**FINAL MITIGATION PLAN**  
**HERON STREAM AND WETLAND MITIGATION SITE**  
Alamance County, North Carolina

DMS Project ID No. 100014  
Full Delivery Contract No. 7192  
USACE Action ID No. SAW-2017-01471  
RFP No. 16-006990

Heron Stream and Wetland Mitigation Site IRT Comment Responses 7/10/2018

Re: NCIRT Review and USACE Approval of the Heron Site Draft Mitigation Plan; SAW-2017-01471; DMS Project #100014

**10C**

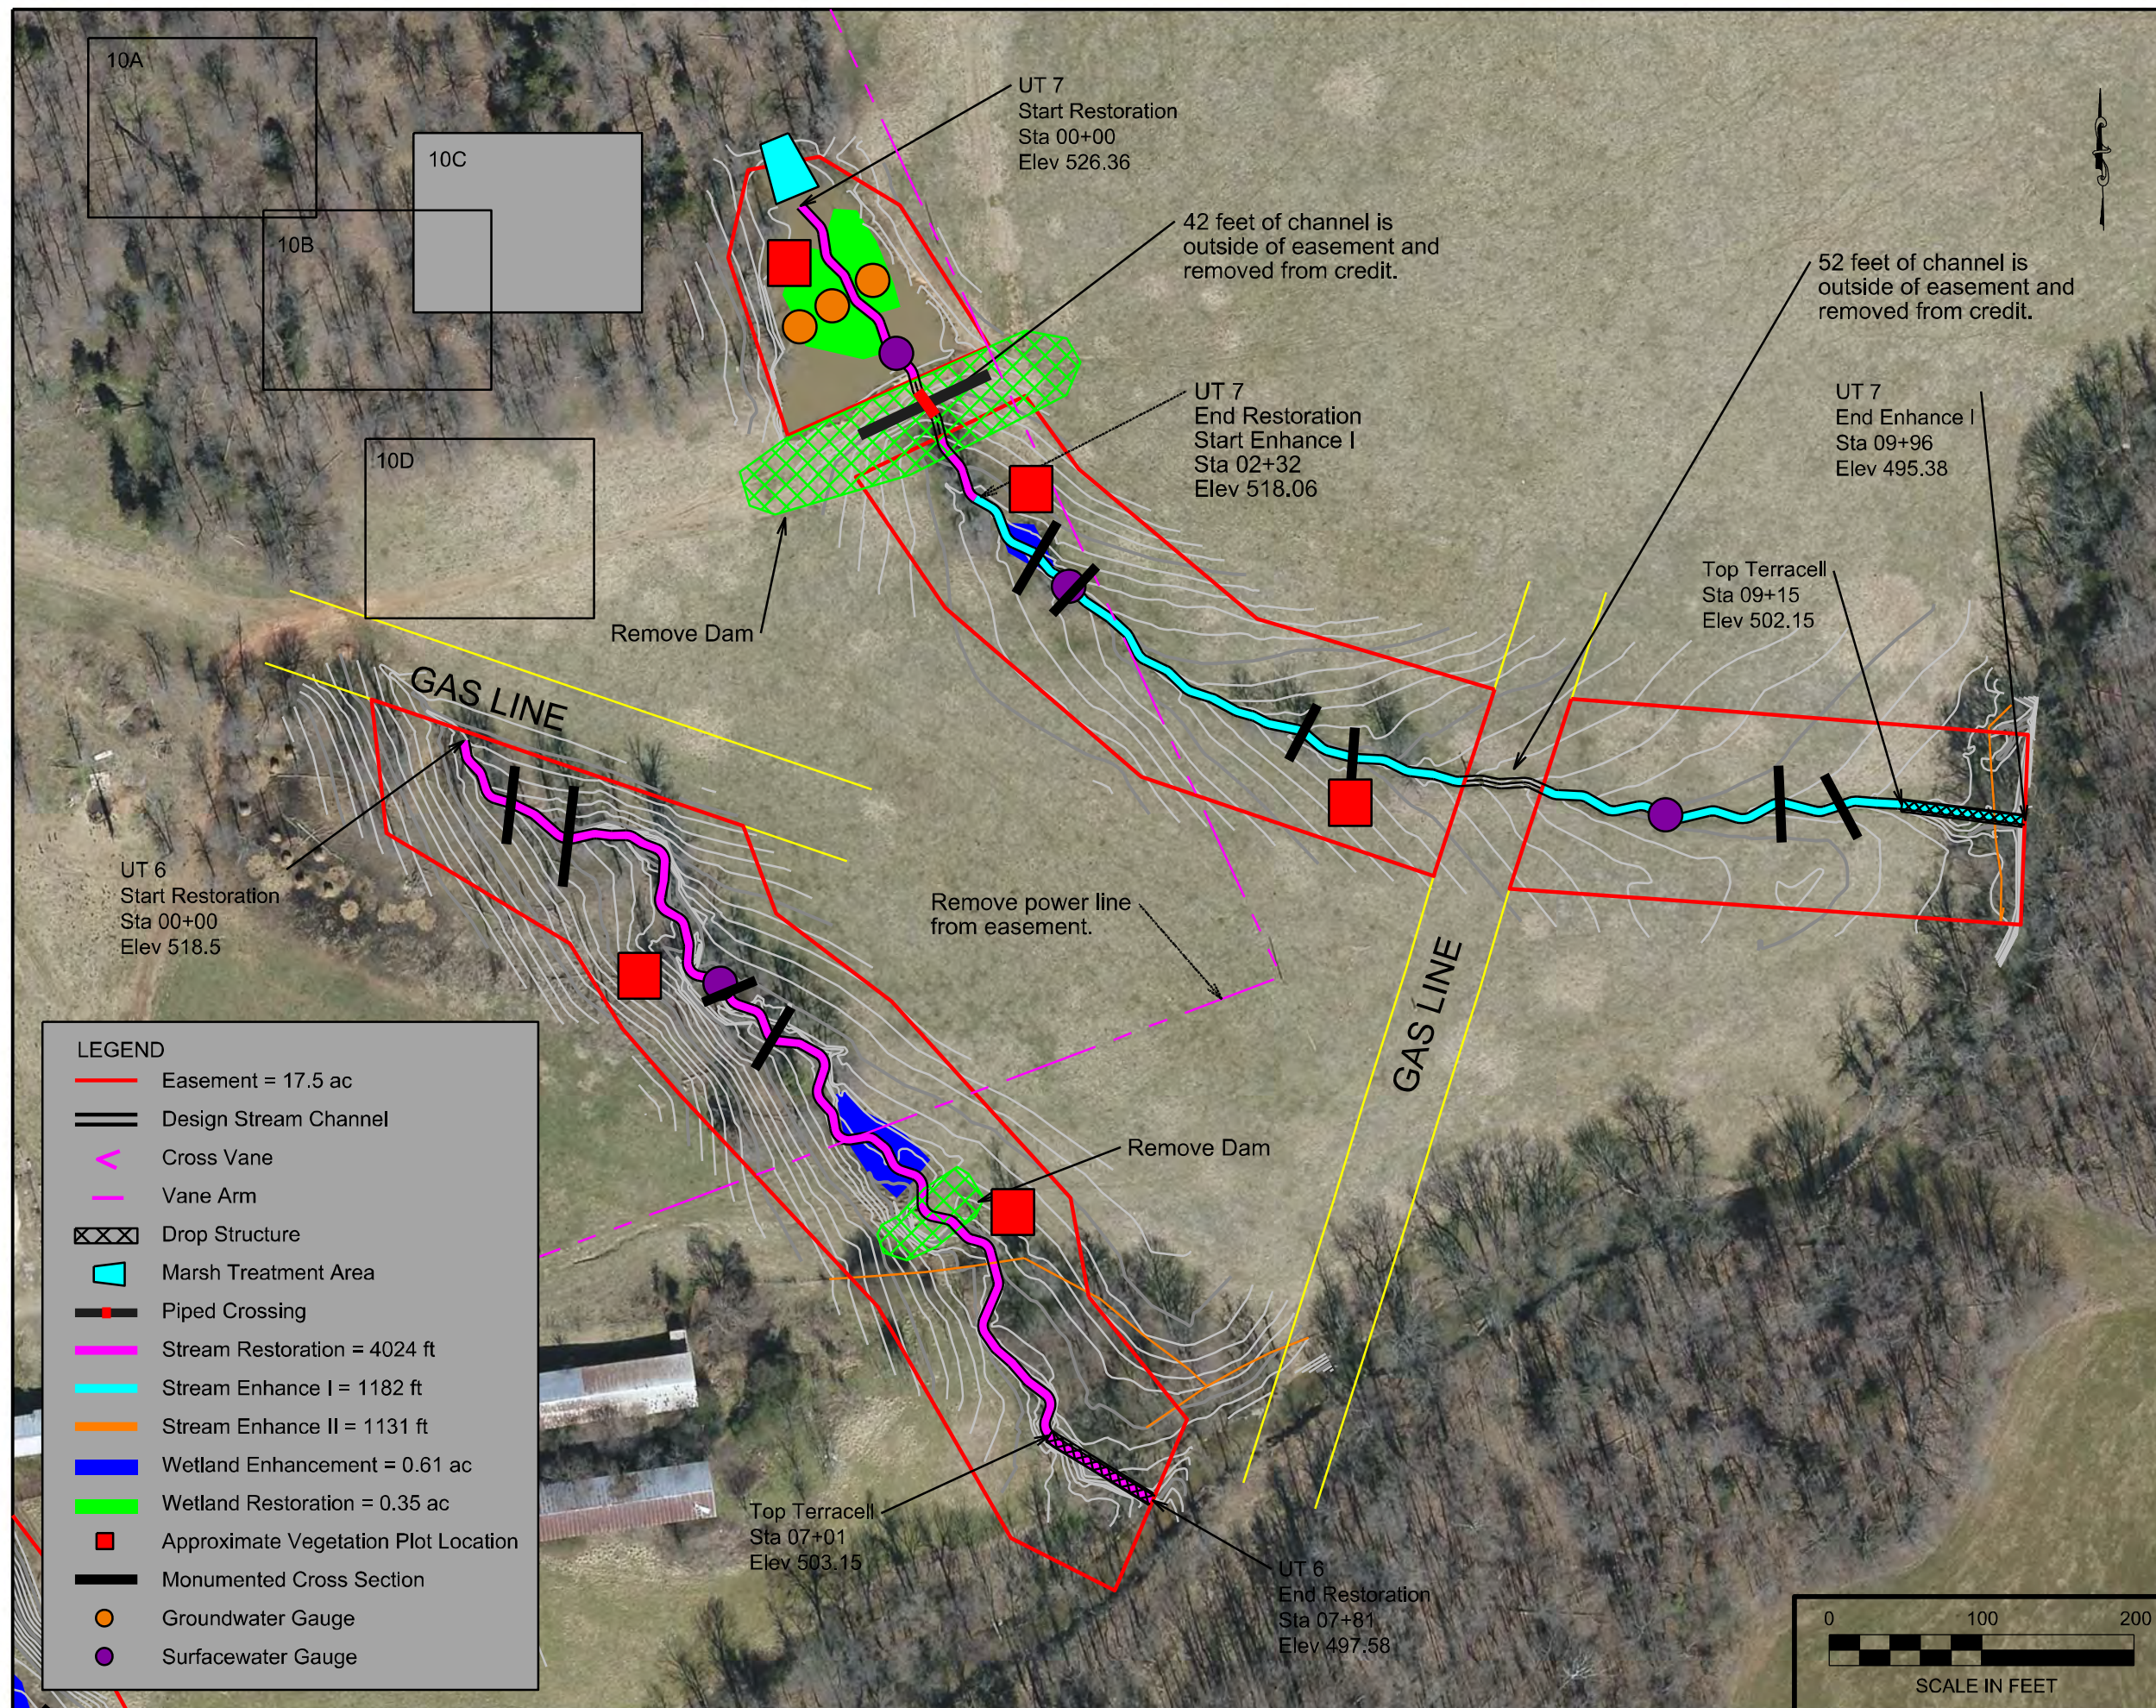
4. DWR requests that a stream gauge be placed at sta 2+75 on UT6.
  - A stream gauge will be placed accordingly and depicted on Figure 10C (Monitoring Plan).

- depicted on Figure 10A (Monitoring Plan).
6. DWR requires that a vegetation plot be placed at the top of UT7 (in the relic pond area), the current proposed plot at the beginning of the Enhancement 1 reach can be moved to the pond area.

- An additional vegetation plot will be located in the relic pond bed and depicted on Figure 10C (Monitoring Plan).
  7. The same requirement goes for the vegetation plot near the top of UT5, please locate the vegetation plot in the relic pond bed.
